Watsonia Construction Compound Plan (CCP)

Vent Office Compound Stage 1

North East Link - Primary Package

Document number: NEL-CNT-SDC-2990-EPA-PLN-0001

Figure 3 Indicative Vent Office Compound

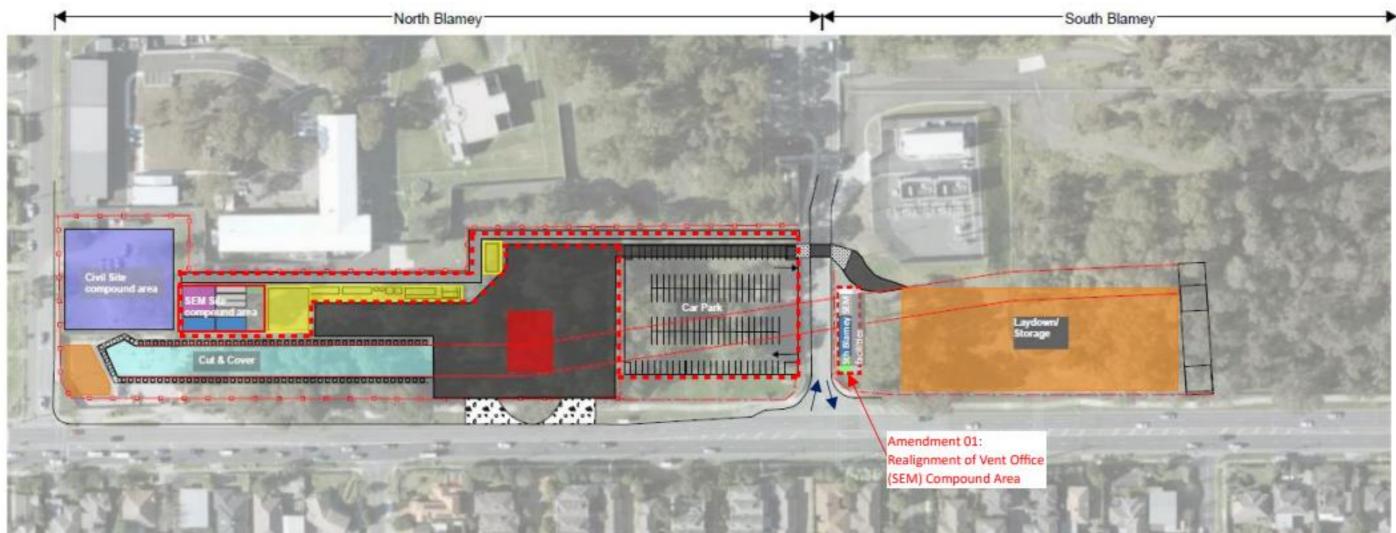
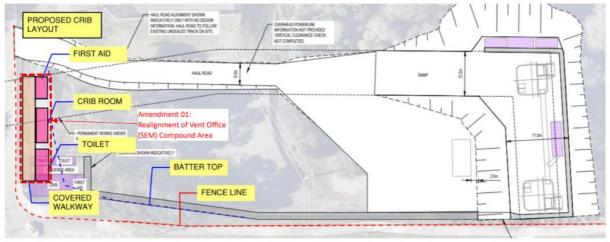
Amendment No.	Date	Location	Description
2	23/06/23	South Blamey, adjacent Blamey Road	Updated Figure 3 (Site Layout Plan) to include re- configured crib layout (one- storey) at South Blamey to align with batter location. Cribs (including first aid room, crib room and toilet as previously endorsed) are placed in line along the

Amendment No.	Date	Location	Description
			Blamey Road fence line with a covered walkway.
			Updates to Figure 2, Figure 3 and Figure 5 have been made for this amendment. A new Figure 4 has also been included showing proposed crib layout re-alignment overlay on previous layout.
			Tables 2 and 8 have been updated to include mobilisation dates (Q3 2023) for the re-aligned South Blamey crib.
